INDESIT company

Model type:
WT6IT

Commercial code:
F026450

FIG. 1

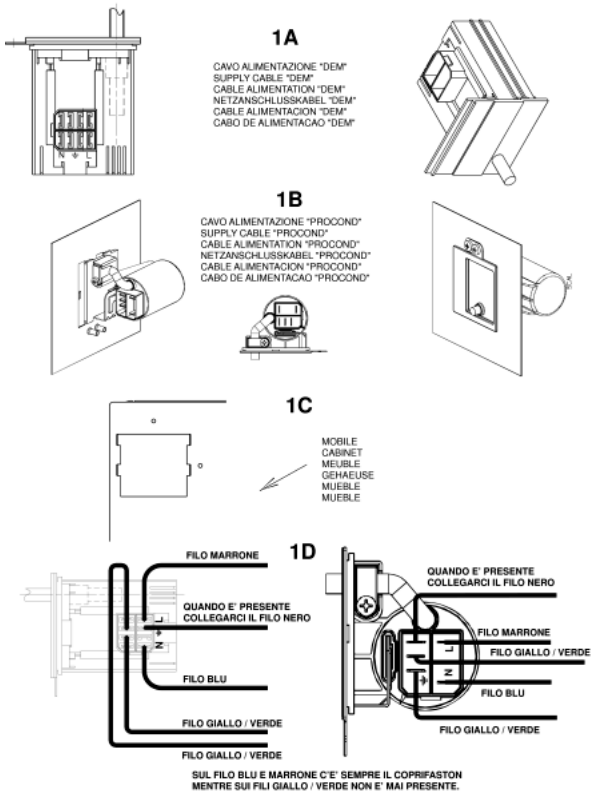
To use premodified wirings on modified products perform the connection to the terminal block of the new cable as shown in fig. 1 - 1D.
The wiring diagrams indicated in the Documentation remain the same.

N1040309FIG1

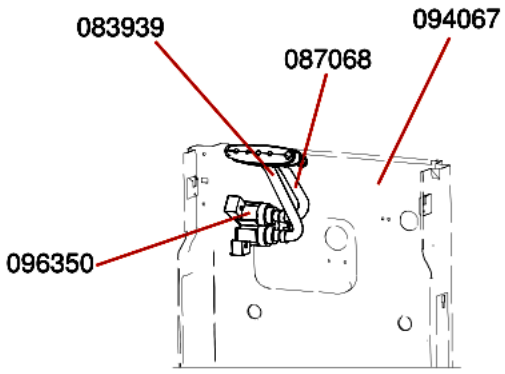
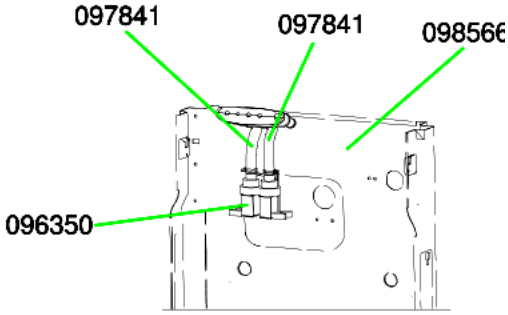
From serial no. 30912.0001, the system used for fixing the loading solenoid valve (spare part code 096350) to the rear panel has been modified on Top Loading washing machines, rotating its position by 90°.
The solenoid valve (spare part code 096350) has been modified with the 45° rotation of a coil; the Replacements Warehouse will continue to manage this part with the same code. When replacing on premodification machines, fit the coils as shown in figure N1040309FIG3-1 and on modified machines, as shown in figure N1040309FIG3-2; to rotate the coil, lift it using a screwdriver and then refit according to the inserts on the plastic.

Replacement codes of the parts affected by this modification (see figure N1040309FIG1):

FIG1 A - PREMODIFICATION STRUCTURE
solenoid valve tube/distributor assembly: premodification 083939;
solenoid valve tube/distributor assembly: premodification 087068;
rear panel: premodification 094067.
FIG1 B - NEW STRUCTURE
solenoid valve tube/distributor assembly: new 097841;
solenoid valve tube/distributor assembly: new 097841;
rear panel: new 098566.

N1040309FIG2

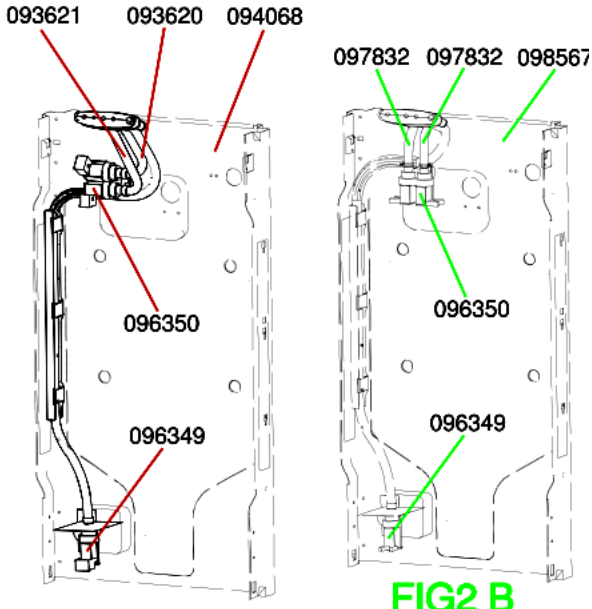
Replacement codes of the parts affected by the modification to WMTL80UK (see figure N1040309FIG2):

FIG2 A - PREMODIFICATION STRUCTURE
solenoid valve tube/distributor assembly: premodification 093620;
solenoid valve tube/distributor assembly: premodification 093621;
rear panel: premodification 094068.
FIG2 B - NEW STRUCTURE
solenoid valve tube/distributor assembly: new 097832;
solenoid valve tube/distributor assembly: new 097832;
rear panel: new 098567.

Premodification panels will be managed by the Replacements Warehouse while stocks last; when replacing with new ones on premodification appliances the new tubes must also also be used.
When using the new panels on appliances before serial no. 30609.0001, fitted with solenoid valve code 083940, rotate the coil 45° and follow the instructions given above for code 096350, paying attention during the wiring phase to keep the cables away from the bowl support spring.

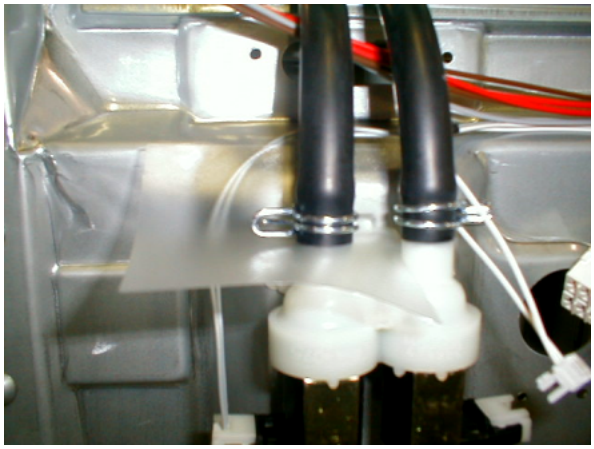
n1040321: Plastic protecion for solenoid valve.

All top-load washing machines produced from September 2003 to February 2004 (from serial no. 30900.0000 to 40300.0000)

have been equipped with a plastic protection Service code 109798 (shown in N1040321FIG1), to prevent water from damaging the solenoid valve and electronic card.

N1040324FIG1

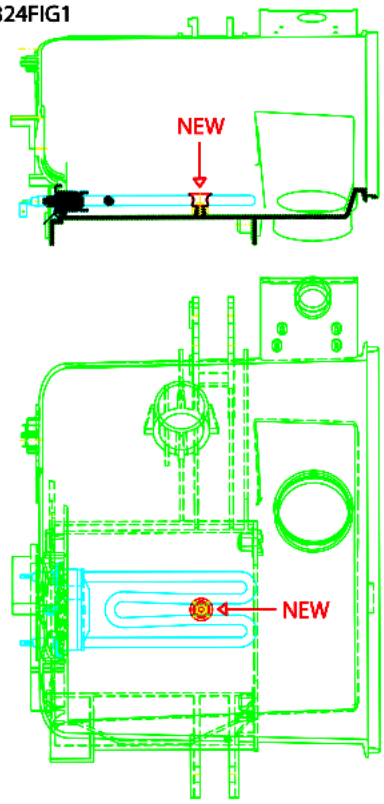
n1040324: Modification of heater fixing system on top-load washing machines.

From serial number 40506.0001, the fixing system of the heater to the tank has been modified on all top-load washing machines affected by this note, with the introduction of a metal retainer (image N1040322FIG1 reference NEW) in place of deflector Service code 055322.

The modification has involved both heater and tanks. Given below are the Service codes of the new and old items concerned:

-PLASTIC TANK FOR 600-1000 RPM MACHINES: new 110152, premodification 083805;

-PLASTIC TANK FOR 1200 RPM MACHINES: new 110153, premodification 092023;

-HEATER: new 110148, premodification 083906.

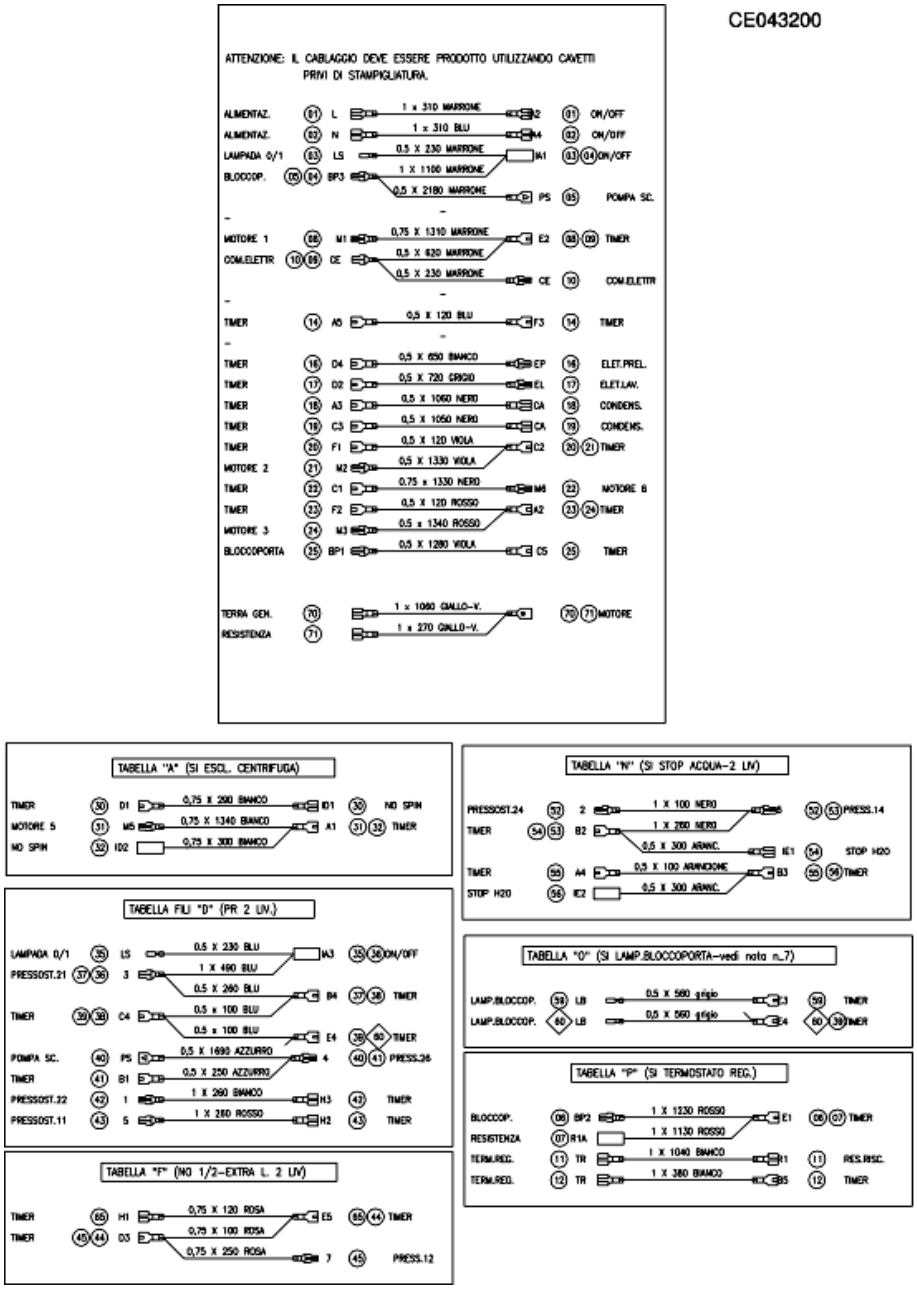
n4009a02: Motor fixing changed on Top Loading washing machines

Top Loading washing machines have changed the fix of motor to the tub.
The tub design is changed in the motor fixing side and two new screws code C00268497 are introduced instead of the old screws C00084333 and the old nut:

In assistance on premodification products with the new tubs, you have to fix the motor using the new screws C00268497 instead of the screws and nut that you find in the product.

s/n 80818.0001 - all models 1400 rpm Collector and Triphase motor

s/n 80818.0001 - all models 600 – 800 – 1000 – 1200 rpm Triphase motor

s/n 90113.0001 - all models 600 – 800 – 1000 – 1200 rpm Collector motor
